Pentium® II Xeon™ Processor Specification Update

Release Date: March 1999

Order Number: 243776-011

The Pentium® II Xeon™ processor may contain design defects or errors known as errata which may cause the product to deviate from published specifications. Current characterized errata are documented in this Specification Update.

Figure 1. An Example of Microcontroller Driven Thermal Management

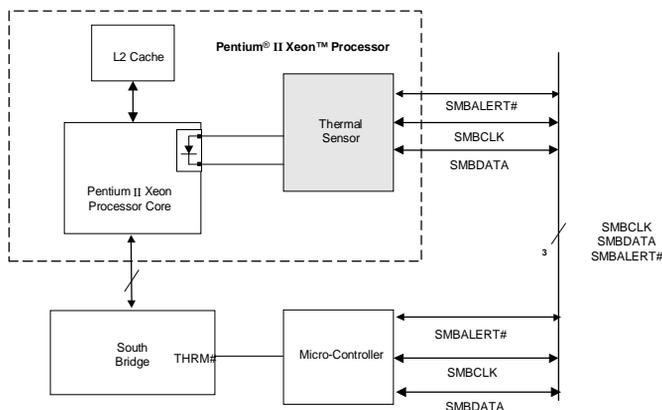
D30. Thermal Sensor May Assert SMBALERT# Incorrectly

PROBLEM: The Pentium II Xeon processor has a thermal sensor that monitors the processor core's temperature. The thermal sensor asserts SMBALERT# if the processor temperature exceeds the temperature limits set in the Alarm Threshold Registers (T_{HIGH} , T_{LOW}). It also sets the corresponding Status Register bits to identify the cause of the interrupt. Figure 1 gives one example of the how the SMBALERT# signal could be used in a system.

Under the conditions described below, the thermal sensor incorrectly generates the SMBALERT# interrupt. *All* of the following conditions must be met to trigger a false interrupt:

WORKAROUND: Three different (mutually exclusive) workarounds are possible:

1. Before servicing an interrupt from the thermal sensor, read and compare the processor thermal reading with the threshold limits (T_{HIGH} or T_{LOW}). Figures 2 and 3 provide basic flowcharts for the implementation of this workaround in an interrupt driven system.
2. If the firmware implemented polls the Status Register only, then before taking any action, re-read the temperature register and do a comparison with the alarm threshold limits (T_{HIGH} or T_{LOW}) to determine if the value is actually still within the temperature window.
3. Use a temperature polling scheme to monitor the processor temperature.
